**FINAL DECISION**  
**Evoenergy**  
**Distribution Determination**

**2019 to 2024**

**Attachment 5**  
**Capital expenditure**

April 2019

**Figure B.3.1 – Feeder level cost-benefit outcomes**

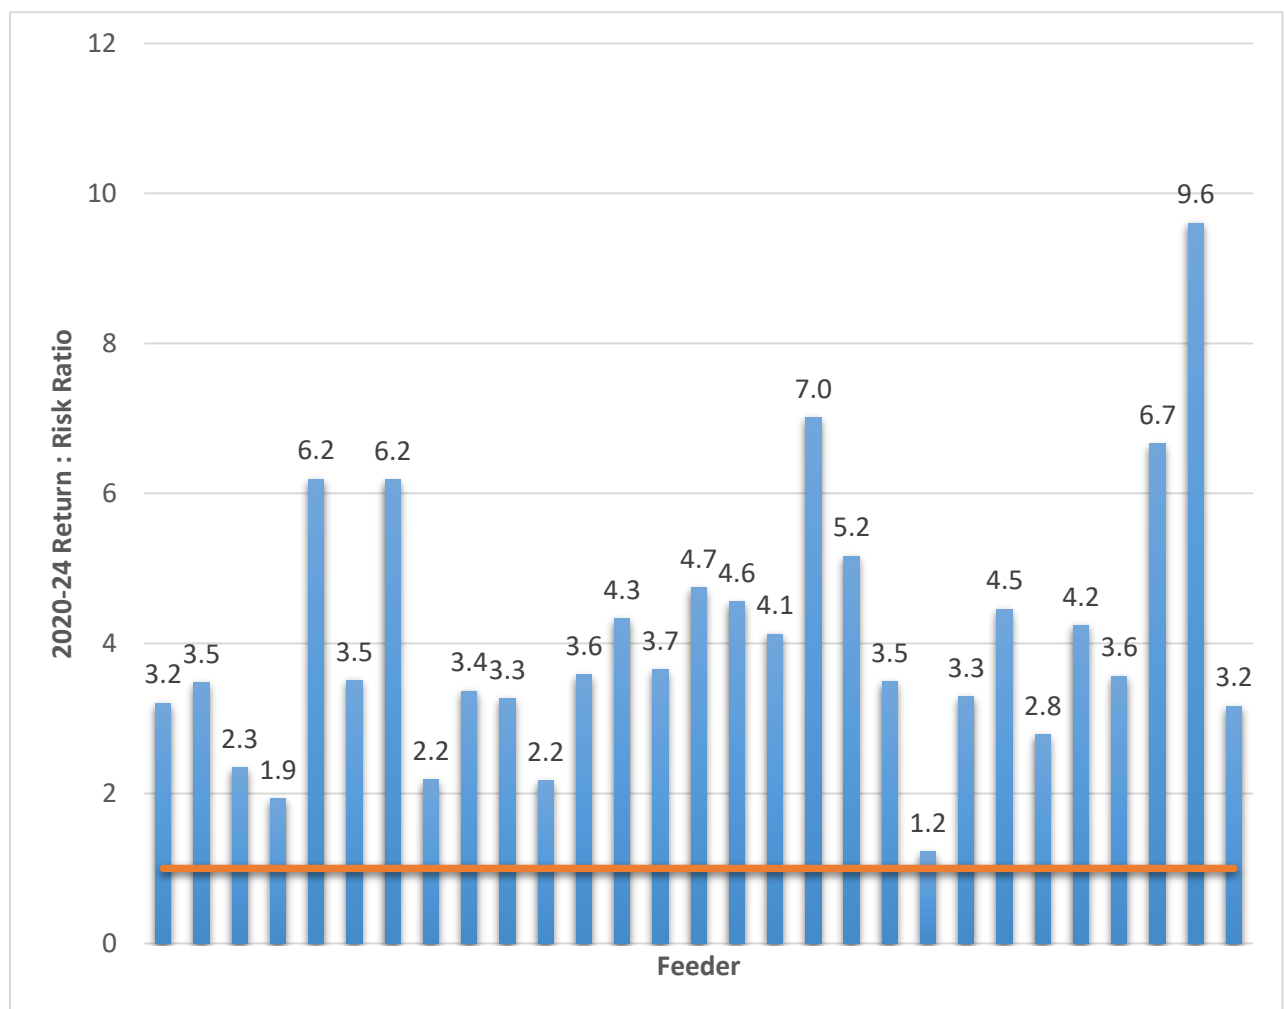
Evoenergy has justified that the proposed quantified benefits of its high-voltage underground cable replacement program, via risk reduction, are likely to exceed the proposed costs. Our draft decision raised concerns with the general safety risk assumptions in Evoenergy's cost-benefit analysis, but its HV cable model clarified that the primary risk associated with its high-voltage underground cables is unserved energy risk.

Overall, Evoenergy's cost-benefit analysis demonstrated that each of its 29 individual high-voltage feeders were cost-benefit positive, i.e. the expected quantified annual risk reduction for each feeder was likely to exceed the annualised program cost over the 2019–24 forecast period.<sup>57</sup> These results are summarised below in Figure B.3.1.

**Figure B.3.2 – Initial repex modelling results (\$2018–19, million)**

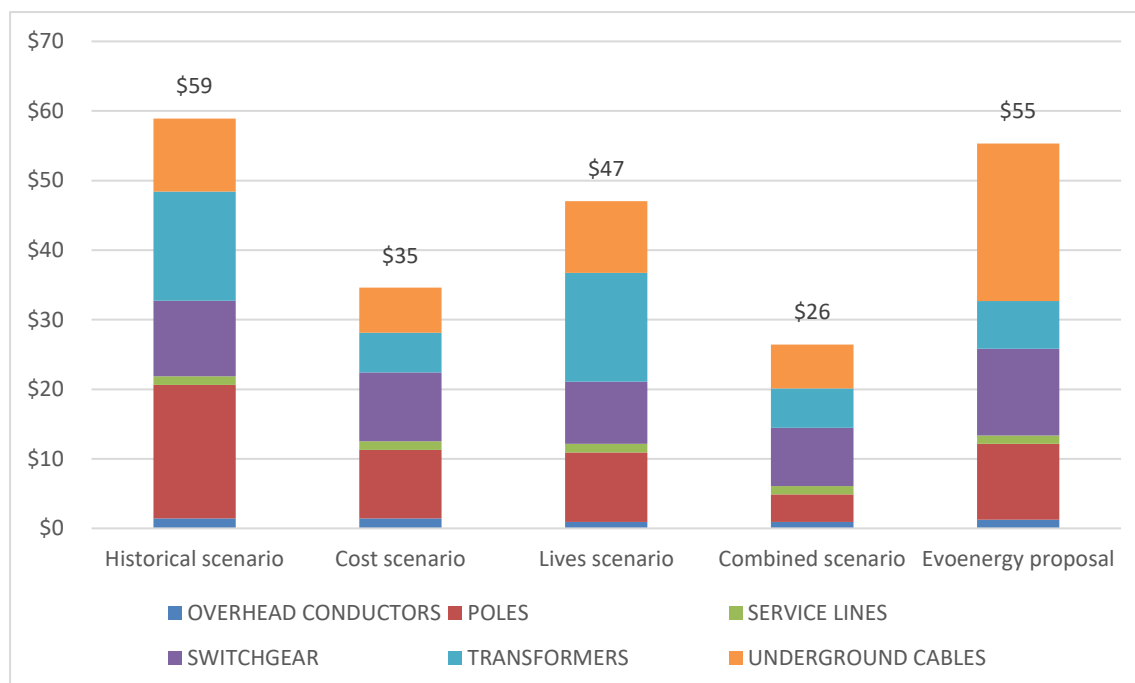
In our draft decision, we presented our initial repex modelling results against Evoenergy's modelled repex forecast. These initial results are outlined below under Figure B.3.2.

In our draft decision, we highlighted that Evoenergy's forecast repex differed most significantly from our initial repex modelling scenarios in the underground cable asset group (again highlighted in Figure B.3.2). In response to our draft decision, Evoenergy raised concerns with the repex modelling inputs, specifically the historical unit cost and calibrated expected replacement life, used for its high-voltage underground asset category.<sup>62</sup>

During the initial proposal stage, we sent Evoenergy an information request in an effort to clarify these underlying data inputs.<sup>63</sup> Evoenergy's response indicated that "some expenditure on cable and overhead conductor replacements may not have been captured"<sup>64</sup> in this historical data, but no recast data was provided. Following our draft decision during our engagement with Evoenergy, we advised that these inputs were based on Evoenergy's historically reported category analysis RIN data.

**Figure B.3.3 – Revised repex modelling results (\$2018–19, million)**

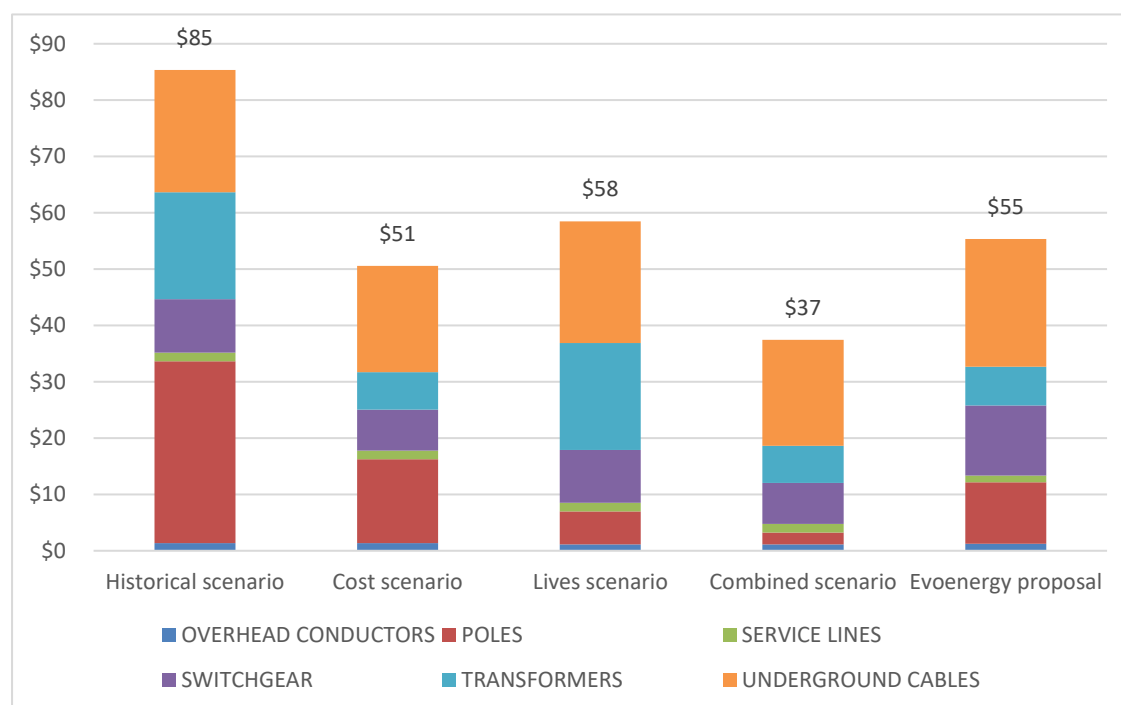
To rectify this data reporting issue, Evoenergy provided updated historical data for its high-voltage underground cable asset category in its revised proposal.<sup>66</sup> This updated data was used to rerun our repex modelling results, which are presented below in Figure B.3.3.

Figure B.3.3 highlights that Evoenergy's modelled repex forecast falls slightly below our updated repex model threshold when more representative repex model inputs are used. The modelled amounts for the underground cable asset group increase most significantly from the initial repex modelling results by adjusting the underlying unit cost and expected asset replacement parameters.

Specifically, a more representative high-voltage underground cable unit cost underpins the results in Figure B.3.3. In addition, using the updated replacement volume data provided produces an inferred calibrated expected replacement life of 87 years, compared with the figure of 100 years used in the draft decision. In its revised proposal, Evoenergy noted:

**Figure E-1: Population by district – Woden zone substation (2006 – 2028)**

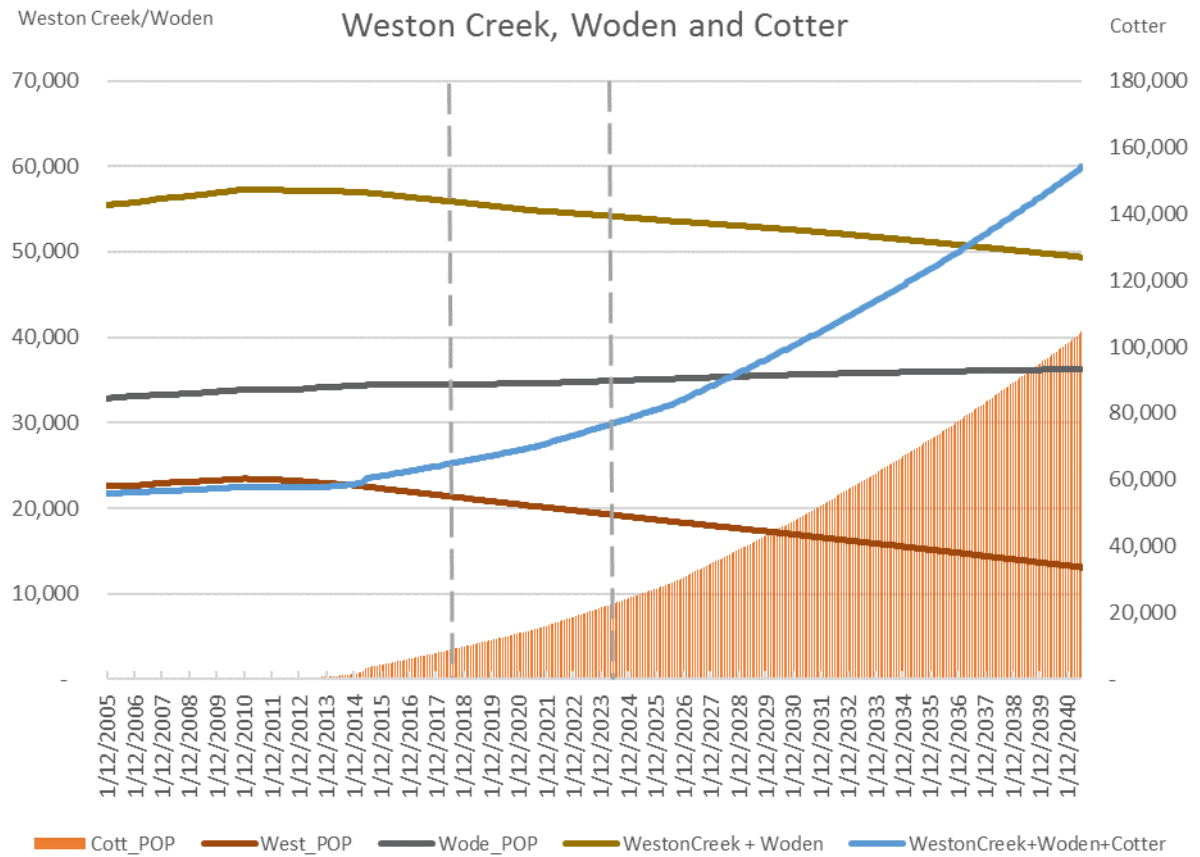
We note that one of the changes made in the seasonal average demand modelling for Woden zone substation is to use the population variable for Woden only.<sup>116</sup> This fails to capture correctly the underlying population being served by Woden zone substation; i.e., two established districts at Weston Creek and Woden respectively, and the newly developed district at Cotter. Using data submitted by Evoenergy,<sup>117</sup> the three districts differ in terms of population size and growth path historically and going forward. See Figure E-1 and Table E-1 below.
